Item 5.**Modification Application: 58-78 and 82-106 Oxford Street, Darlinghurst - D/2020/1071/C****File No.:** D/2020/1071/C**Summary****Date of Submission:** 10 February 2023, further information was supplied 26 May 2023 and 2 August 2023**Applicant:** Daniel Litchfield**Architect/Designer:** FJMT Studio**Owner:** The Council of the City of Sydney**Planning Consultant:** Jethro Yuen - Ethos Urban**Heritage Consultant:** Paul Davies Pty Ltd**Cost of Works:** \$44,085,318**Zoning:** The site is located in the E1 Local Centre zone.

Proposal Summary: The application seeks consent for a section 4.55(2) modification to the approved mixed-use development currently under construction at 82-106 Oxford Street, Darlinghurst.

Figure 38: Comparison between the approved lower ground floor level and the proposed lower ground level showing reconfigured End of Journey and bicycle parking, removal of loading dock door, removal of storage area, window modifications and new lift core location

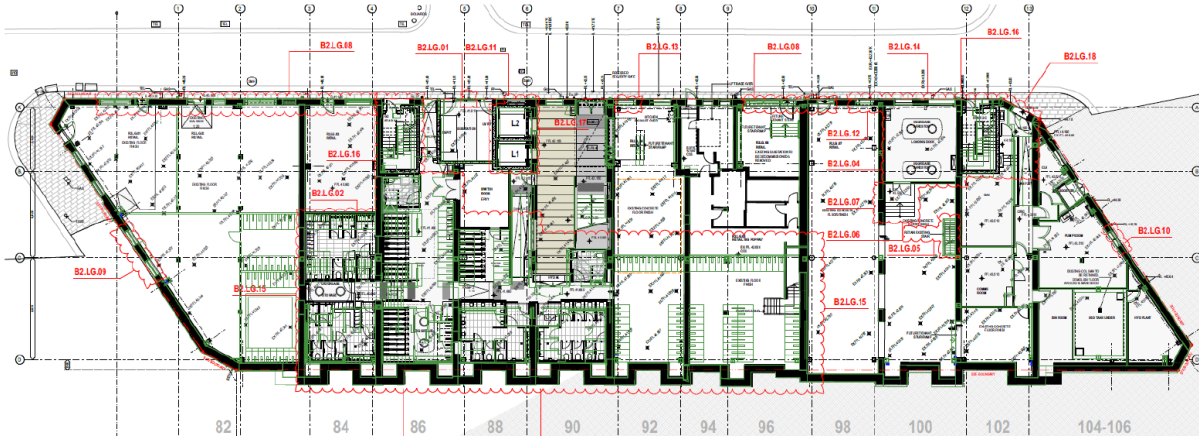
Drawing references and condition amendments	Proposed modifications and applicant's submission	Assessment
Lower ground		
B2.LG.01	Remove the existing pier at gridline 5 on the Foley Street elevation to meet Ausgrid substation requirements.	This change has been reviewed by the City's Heritage Specialist who advised that the removal of the pier will have a minor heritage impact and is acceptable.
B2.LG.02	Reduction of end of journey floor area with some efficiencies achieved through double-stacked bicycle parking.	<p>The reduction in end of journey floor area and reconfiguration of the bicycle parking facilities are supported, as there are no planning, transport or heritage impacts arising as a result of the modifications.</p> <p>Five additional staff bicycle parking spaces and six additional visitor bicycle parking spaces have been added.</p> <p>The City's Transport Specialist reviewed the proposed modification and advised that the proposed bicycle parking provision is compliant with the requirements in Section 3.11.3 of the Sydney Development Control Plan 2012.</p>

B2.LG.03	The public bathrooms are proposed to be reconfigured.	The change to the bathroom is a reconfiguration of previously approved new fabric. The change is supported, as there are no planning or heritage issues arising as a result of the modification.
B2.LG.04	Grease arrestors are proposed to be relocated.	The change to the location of the grease arrestor is supported as it involves reconfiguration of previously approved new fabric. There are no planning or heritage issues arising as a result of the modification.
B2.LG.05	The existing stairs between the ground floor and lower	This change will allow for the reinstatement of the original

Drawing references and condition amendments	Proposed modifications and applicant's submission	Assessment
	ground within 100 Oxford Street are proposed to be reopened.	circulation path through this part of the building, with no changes to original building fabric (except for make good / refurbishment works). The proposed modification will have a positive heritage impact and is supported.
B2.LG.06	New internal access to the loading dock is proposed to be provided from 100 Oxford Street.	This new internal access to the loading dock is supported as it does not result in any detrimental heritage impacts.
B2.LG.07	The previously approved door opening in the existing masonry wall between 98 and 100 Oxford Street along gridline 11 is proposed to be deleted. New lightweight fire rated infill walls are proposed for the remaining approved openings.	This change to delete this previously approved opening is supported as it will enable the retention of a higher degree of original building fabric and retain legibility of the original layout of this part of the building which is a positive heritage outcome.

B2.LG.08	The shopfront designs for No 82, 84, 96 and 98 Foley Street are proposed to be modified.	<p>The proposed shopfront modifications to Foley Street are supported as no change is proposed to the approved shopfront opening sizes or materiality.</p> <p>The proposed modifications have been reviewed by the City's Heritage Specialist and are supported. There are no planning or heritage issues arising as a result of the modifications.</p>
B2.LG.09	The existing windows SW.B20B.17 and SW.B20B.18 on the lower ground floor of Crown Street are proposed to be retained, conserved and resealed as they have been found to be early or original windows.	The proposal is supported as it results in retention, conservation and resealing of an existing heritage window. The proposed modification results in the retention of original fabric and is a positive heritage impact.

Drawing references and condition amendments	Proposed modifications and applicant's submission	Assessment
B2.LG.10	The existing window VXHM.B20B.01 on the basement level of Palmer Street is proposed to be removed and replaced with a new steel frame and metal louvres for mechanical intake.	The modification to window VXHM.B20B.01 is supported as it allows for mechanical ventilation of the building using existing window openings and is reversible. The modification has a minor heritage impact.
B2.LG.11	An existing opening to Foley Street, SW.B20B.10, was uncovered during site investigations. An opening (type WT04) is now proposed as it is located within the Substation blast zone and to the rear of the new lift core.	The modification to retain the existing opening is supported. Noting that the opening has been previously enclosed and that it is also located within the Substation blast zone, the new steel-framed blind opening is considered appropriate as it will provide a suitable contrast to the existing, early timber windows which are to be retained and will therefore not impact the character or legibility of this part of the building.

B2.LG.12	The existing non-original window SW.B20B.03 is proposed to be removed and replaced with a steel framed fixed shopfront detailed to match the other new basement shopfronts to Foley Street.	The proposed modification is supported as window SW.B20B.03 is a non-original window and is heavily altered. The proposed change was reviewed by Council's Heritage Specialist who confirmed the change does not result in impacts to original heritage fabric and is acceptable.
B2.LG.13	The approved Architectural Drawings show an existing window at the opening of SW.B20B.08. However, following site investigations, this existing window was not located. Therefore, a new shopfront window is proposed within this existing opening.	The modification is supported as it will not change the existing approved opening dimension or location and will not have any heritage impacts.
B2.LG.14	The Loading Dock is proposed to be changed to a receiving dock to conserve	The proposed removal of the on-site loading zone is supported in this instance as it results in

Drawing references and condition amendments	Proposed modifications and applicant's submission	Assessment
	and stabilise the existing brick façade, as constructing a loading dock would require extensive demolition of heritage fabric and additional structural strengthening intervention to heritage fabric.	reduced impacts to heritage fabric of the building and is in accordance with Section 5.11.7(4) of the Sydney Development Control Plan 2012. This control states that loading and servicing facilities are not required to be accommodated on site where there is an adjacent laneway. See further details in the Discussion section below in this report.
B2.LG.15	A portion of end of journey and storage space is proposed to be converted to retail floor space.	<p>The proposed extension of the retail space into the previously approved end of journey and storage space is supported as the development will still maintain compliance with the alternative floor space ratio control (4.5:1) for the site under the Sydney Local Environmental Plan 2012.</p> <p>See further details regarding the proposed redistribution of floor space in the Discussion section below.</p>

Drawing references and condition amendments	Proposed modifications and applicant's submission	Assessment
	to shift in accordance with the proposed layout of the lift core.	
B2.LG.18	The gas metre room is proposed to be reconfigured due to the shift in location of Stair 2C. The access to this room is proposed changed from the previously approved door to new gates.	The change to the gas metre room is supported as it results in reconfiguration of previously approved new fabric. The change is supported, as there are no planning or heritage issues arising as a result of the modification.
B2.LG.19	Change to replace reference to 'loading dock' with 'receiving dock'.	The proposed removal of the loading dock reference is supported as the removal of the loading dock is supported. See further details within the Discussion section of this report under the heading 'Removal of Loading Dock'.
B2.LG.20	Tenancy at 96 Oxford Street fronting Foley Street now identified as Cultural and Creative floor space.	The reconfiguration of cultural and creative floor space is supported as the proposal continues to maintain an additional 10% of the floor space for cultural and creative purposes in accordance with clause 6.60D of the Sydney LEP 2012 and the original conditions of consent.

Figure 39: Comparison between the approved ground floor level and the proposed ground level showing booster to Palmer Street, new lift core location, reconfigured cultural and creative space and window modifications

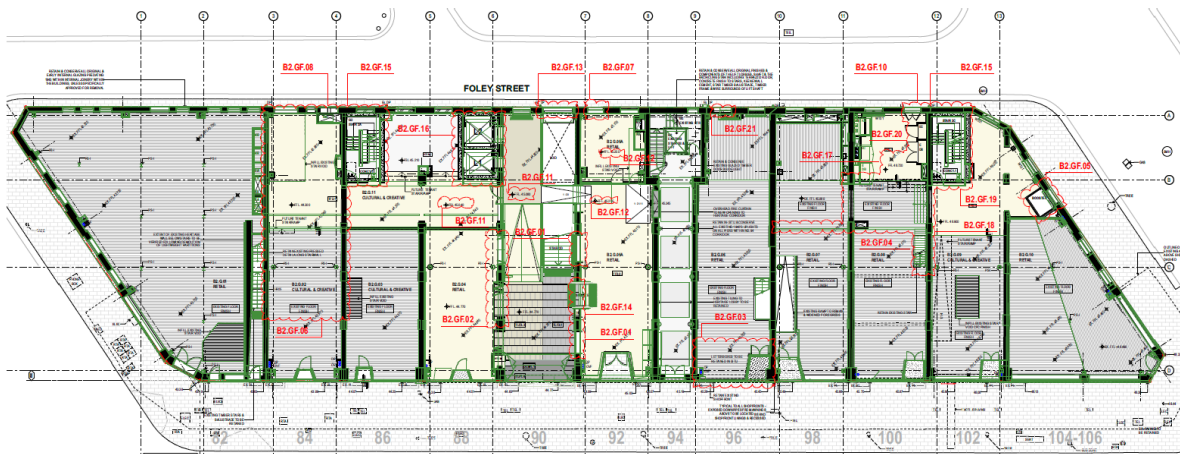
Ground floor		
B2.GF.01	Two additional 2170mm wide openings are proposed in the wall immediately west of gridline 7.	The proposed change is supported as it is a minor change to enhance circulation within the new tenancy. The changes will not adversely impact legibility of the existing original intertenancy walls within the space. The heritage impacts are therefore acceptable.
B2.GF.02	The existing opening dimensions and nibs are proposed to be retained.	The modification is supported as it results in the retention of more heritage fabric than previously

Drawing references and condition amendments	Proposed modifications and applicant's submission	Assessment
		approved and is a positive heritage outcome.
B2.GF.03	The shopfront of the existing Big Poppa's tenancy at 96 Oxford Street is proposed to be retained	The shopfront change is supported as it will not change existing fabric and will have no heritage impacts.
B2.GF.04	The existing stairs between the ground floor and lower ground within 100 Oxford Street are proposed to be reopened.	The reopening of the existing stair is supported as it will allow for the reinstatement of the original circulation path through this part of the building, with no changes to original building fabric (except for make good / refurbishment works). The proposed modification will have a positive heritage impact.
B2.GF.05	The location of the booster enclosure on Palmer Street is proposed to be adjusted based on existing site conditions and access constraints on Palmer Street.	The location of the new booster enclosure on Palmer Street is supported as it will not impact the existing opening proportions or presentation to this secondary frontage.

B2.GF.06	The cultural and creative tenancy at 84 Oxford Street, which is currently split between a front and rear tenancy, is proposed to be amalgamated.	The tenancy amalgamation is supported as it results in a removal of a non-original partition and will have no heritage impact.
B2.GF.07	The non-original window WXHA.B20G.12 is proposed to be removed and replaced with a new steel framed fixed glazed shopfront with a new sloped square edge brick sill to match the sloping brick sill of the adjacent window, WXHA.B20G.11.	Proposal is to remove and replace window WXHA.B20G.12 is supported as the existing window is non-original and has been heavily altered. The use of a square brick sill rather than a bullnose brick sill will distinguish the modern opening from the original openings.
B2.GF.08	Windows WXH.B20G.31 and WXH.B20G.32 and the	The modification to windows WXH.B20G.31 and WXH.B20G.32

Drawing references and condition amendments	Proposed modifications and applicant's submission	Assessment
	brickwork between are proposed to be removed for installation of new mechanical intake louvres to achieve compliance with the BCA and improve amenity for users of the building.	is supported as it allows for mechanical ventilation of the building using existing window openings and will not impact the heritage fabric of the building. Additionally, existing window WXH.B20G.33 is proposed to be retained in-situ.
B2.GF.09	Metal plates over the existing awning downpipe locations along the Oxford Street shopfronts are proposed. These plates are proposed to sit flush with the finished façade and can provide future access. These are to be painted to match the finished façade.	The proposed modification to use metal plates over downpipes is supported as it will allow easy access to the pipes for maintenance and is a designed solution that does not involve any loss of heritage value. Council's Heritage Specialist advised that the proposal was acceptable from a heritage perspective.

B2.GF.10	The existing timber doors behind window WXM.B20G.06 are proposed to be retained.	The modification to retain existing timber doors, which are likely early doors, is supported as it is a positive heritage impact and will not have any planning implications.
B2.GF.11	The floor levels to the rear Cultural Creative space and Lift Lobby on the Architectural Drawings are proposed to be revised following the latest site surveys.	The proposed floor level change from 44.965 FFL to 45.040 and 45.060 is supported as it is a minor change as a result of design development and will have no heritage or planning implications.
B2.GF.12	The floor levels of 92 Oxford Street the Architectural Drawings are proposed to be revised following the latest site surveys.	The proposed floor level change from 44.965 FFL to 45.255 is supported as it is a minor change as a result of design development and will have no heritage or planning implications.

B2.GF.13	The fixed glazed window above the through-site link is proposed to be revised to contain an operable louvred window to allow for direct	The proposed change to include window louvres is supported as it will not impact original/ significant fabric and will not change the

Drawing references and condition amendments	Proposed modifications and applicant's submission	Assessment
	outside air into internal spaces to achieve compliance with the BCA and improve amenity for users of the building.	visual presentation of the approved through-site link. The change will ensure the building achieves compliance with the BCA, improves amenity for users of the building and will have no heritage or planning implications.
B2.GF.14	The approved opening on gridline 7 immediately south of gridline C is proposed to be extended to the south to match the opposite existing opening on gridline 6.	The extended opening is supported as it is necessary to accommodate fire safety requirements. The change will not adversely impact the overall legibility of the tenancy and there are no planning or heritage issues arising as a result of the modification.
B2.GF.15	Stair 2A and 2C which were previously proposed for full demolition, are proposed to be relocated off the existing party wall near gridlines 4 and 12, respectively. A new core is proposed comprised of a retained existing party wall on one side and new concrete walls to the other three sides.	The proposed relocation of stair 2A and 2C is supported as it results in reduced demolition of original fabric, less stabilising works and is a positive heritage outcome.

B2.GF.16	The new lift core is proposed to be relocated east of the existing party wall on gridline 6 which was previously proposed for full demolition. New openings for access to the lift are proposed.	The lift core relocation is supported as it will reduce vertical cuts through the existing cross bracing walls and will result in the retention of more original heritage fabric.
B2.GF.17	The floor level to the rear of 100 Oxford Street is proposed to be revised to achieve compliant loading	The proposed floor level change to FFL 46.720 is supported as it is a minor change as a result of design development, will allow for compliant loading/receiving dock

Drawing references and condition amendments	Proposed modifications and applicant's submission	Assessment
	dock head height requirements.	head height and will have no heritage or planning implications.
B2.GF.18	The configuration of cultural and creative spaces to the rear of 100 and 102 Oxford Street are proposed to be revised.	The reconfiguration of cultural and creative floor space is supported as the proposal continues to maintain an additional 10% of the floor space for cultural and creative purposes in accordance with clause 6.60D of the Sydney LEP 2012 and the original conditions of consent.
B2.GF.19	The egress to Stair 2C on the ground floor is proposed to be removed.	The change to the egress of stair 2 is supported as it is a minor change to non-original fabric and will have no heritage or planning implications.
B2.GF.20	Electrical services are proposed to be relocated.	The repositioning of the electrical services is supported as it is a minor change to non-original fabric and will have no heritage or planning implications.

B2.GF.21	For alterations to WXH.B20G.09, it is proposed to retain the existing timber frame, sashes and glazed louvres on eastern side, and remove the glazed louvres on western side and replaced with new fixed glazing.	The proposed changes to window WXH.B20G.09 are supported as they do not result in a change to the size and location of the existing window. The change will have minimal heritage and planning implications.
B2.GF.22	The extent of the reinstated heritage ceiling is proposed to be amended.	The proposal to amend the extent of reinstated ceiling is supported as it is a minor change which is a result of the repositioned stair and lift cores (noted elsewhere in this table). The proposed change has been reviewed by the City's Heritage Specialist and is acceptable from a heritage perspective.

Figure 40: Comparison between the approved level 1 floor plan and the proposed level 1 floor plan showing removal of eastern lightwell ribs, new internal openings, revised bathroom layout, retention of stair 2A and 2C and new lift core location

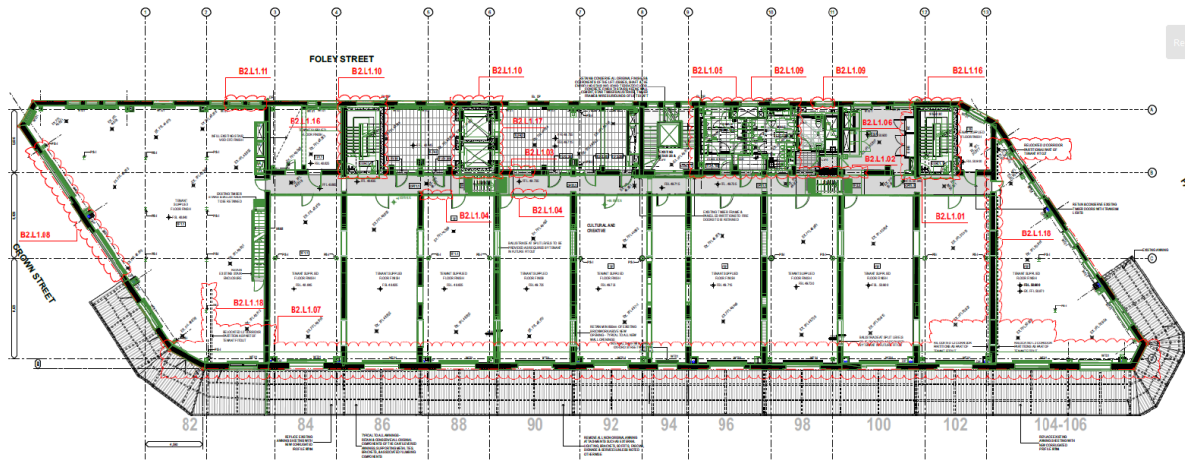
Drawing references and condition amendments	Proposed modifications and applicant's submission	Assessment
Level 1		
B2.L1.01	The eastern lightwell nibs are proposed to be removed for the new fire stairs to meet BCA and structural requirements.	The proposed removal of the lightwell nibs is supported. This change is required to ensure building code compliance of the new fire-isolated stairs and supporting information has been submitted to demonstrate that the removal of the wall nibs will not generate adverse structural impacts. The former lightwell will remain readily interpretable and the change will have a minimal impact on heritage fabric.
B2.L1.02	New openings to the existing masonry wall adjacent to gridline 11 are proposed to provide a compliant access path to the platform lift.	The proposed new openings to the wall along gridline 11 are supported as they will ensure a compliant access path to the platform lift. The proposed openings will result in the removal of a small amount of brickwork, however they will not adversely affect the legibility of the retained corridor.

B2.L1.03	New openings to the existing masonry wall adjacent to gridline 11 are proposed to provide a compliant access path to the main lift lobby.	The proposed new opening from the main lift to the lobby is supported as it will ensure a compliant access path from the main lift. The proposed opening will result in the removal of a small amount of brickwork, however it will not adversely affect the legibility of the retained corridor.
B2.L1.04	It is proposed to remove two modules within the heritage timber panels from the floor to head height on the southern alignment of the east west corridor immediately east of gridlines 5 and 6 to allow access from	<p>The modification to create two new openings to allow more direct movement from lifts and stairs to the floor plates is supported.</p> <p>The corridor form remains and most of the partitions remain as already approved. The upper level glazed elements that are clear to view also remain with the</p>

Drawing references and condition amendments	Proposed modifications and applicant's submission	Assessment
	the lift areas to the main commercial office space.	openings in the lower section of the solid partition. The modification is considered to result in an acceptable heritage outcome.
B2.L1.05	The bathroom layout is proposed to be revised.	The change to the bathroom is a reconfiguration of previously approved new fabric. The change is supported, as there are no planning or heritage issues arising as a result of the modification.
B2.L1.06	Electrical services are proposed to be relocated.	The repositioning of the electrical services is supported as it is a minor change to non-original fabric and will have no heritage or planning implications.
B2.L1.07	The original floorboard perimeter that is exposed along Oxford Street is proposed to be covered by a new structural plywood floor strengthening diaphragm.	The proposed modification for a new structural plywood floor strengthening diaphragm is supported. The method is considered acceptable by Council's Heritage Specialist as it retains the original floorboards in situ and avoids damage to them caused by lifting.

Drawing references and condition amendments	Proposed modifications and applicant's submission	Assessment
	retained and the glazing replaced with metal louvres.	
B2.L1.10	Windows, WXH.B201.31 and WXH.B201.34 back onto the new lift core and new stair core, respectively. It is proposed to replace the glazing on window WXH.B201.31 with colour backed (black) strengthened glass to prevent glass from shattering when the cavity between the existing façade and new lift core is subject to high heat.	The proposed change to window WXH.B201.31 is acceptable as it is minor work required for safety purposes, which will not adversely affect the legibility of the retained timber sash frame, the existing opening proportion, or the arched brick header. The modification will have no unreasonable heritage impacts and is easily reversible.
B2.L1.11	The non-original windows WXHA.B201.37 and WXHA.B201.38 are proposed to be removed and replaced with new timber single double hung windows to match the original timber single double hung window WXHA.B201.39.	The replacement of non-original windows with timber windows is supported as they will match the original single timber double hung window WXHA.B201.39 which is a positive heritage outcome.

B2.L1.12	The fixed central east-west bulkhead between gridlines C and D is proposed to be replaced with a suspended decorative ceiling services shroud.	The proposal to replace the approved bulkhead with a suspended decorative ceiling services shroud is supported as it involves the removal of a new element and replacement with another new element and will not have an impact on any heritage fabric.
B2.L1.13	The plain plaster ceiling above the central corridor is proposed to be removed and reinstated with a new plain plaster ceiling matching the existing level and detailing in order to facilitate access to spaces	The replacement of the plain plaster ceiling is supported as it facilitates removal of fabric of little relative significance, in order to facilitate access during construction works. Replacement with like-for-like will allow for retained legibility of this part of the

Drawing references and condition amendments	Proposed modifications and applicant's submission	Assessment
	above the ceiling during construction.	building. This modification will have no adverse heritage impacts.
B2.L1.14	The proposed ceiling fittings have been included in the amended Architectural Drawings. The finished ceiling levels are also proposed to be revised to suit the reconfigured spaces and new survey information.	The reconfiguration of previously approved modifications to the ceilings to accommodate required new services is supported. The proposed changes are necessary, minor and on the whole will not adversely impact the legibility of the reinstated, original moulded plaster ceilings.
B2.L1.15	The plain plaster heritage ceiling panels along the perimeter are proposed to be removed to allow for the installation of structural members to the existing façade for seismic strengthening. New ceiling panels are proposed to be installed to match the existing plain plaster heritage ceiling panels.	The replacement of the plain plaster ceiling is supported as it facilitates removal of fabric of little relative significance, in order to allow for structural works. Replacement with like-for-like will allow for retained legibility of this part of the building. This modification will have no adverse heritage impacts.

Drawing references and condition amendments	Proposed modifications and applicant's submission	Assessment
B2.L1.18	The Level 2 heritage timber partitions are proposed to be reused at various locations across Level 1.	The retention and reuse of the heritage timber partitions is supported as it is a positive heritage outcome.
Level 2		
B2.L2.01	The eastern lightwell nibs are proposed to be removed for the new fire stairs to meet BCA and structural requirements.	The proposed removal of the lightwell nibs is supported. This change is required to ensure building code compliance of the new fire-isolated stairs and supporting information has been submitted to demonstrate that the removal of the wall nibs will not generate adverse structural impacts. The former lightwell will remain readily interpretable and the change will have a minimal impact on heritage fabric.
B2.L2.02	The heritage timber partitions are proposed to be removed and reused on Level 1 (subject to a separate application).	The retention and reuse of the heritage timber partitions is supported as it is a positive heritage outcome. This element is subject to separate tenancy fit out application D/2023/228 which is currently under assessment.
